Docket No. PROJ 0782

KHNP Response to RAI 4-7542 on Topical Report
“PLUS7 Fuel Design for the APR1400”
APR1400-F-M-TR-13001-P Rev.0

June 2014

RESPONSE TO REQUEST FOR ADDITIONAL INFORMATION 4-7542

*Figure 6-1 Measured Total Elongation vs Hydrogen Content
(Irradiated fuel cladding & Tested at 300 °C or 350 °C)*

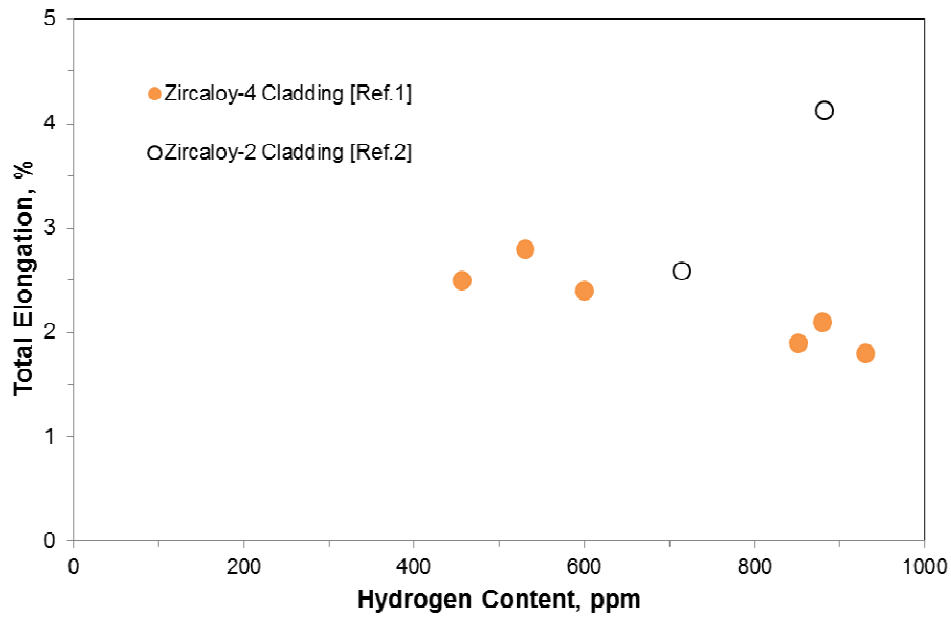
The proposed oxide limit in Section 3.2.4 of APR1400-F-M-TR-13001-P is 100 μm . Figure 4-44 indicates that cladding with 100 μm of oxide thickness would exceed the 600 ppm hydrogen content limit, which would lead to a loss of ductility. How does the use of a 100 μm oxide thickness limit support the 1% strain criterion?

In conclusion, ductility is not significantly affected at operating temperatures and not susceptible up to hydrogen levels of 930 ppm shown in Figure 6-1. Therefore, as the 1% strain limit for cladding ductility was introduced to preclude excessive cladding deformation during normal operation and anticipated operational occurrences (AOOs), the 100 μm oxide thickness limit still supports the 1% strain criterion.
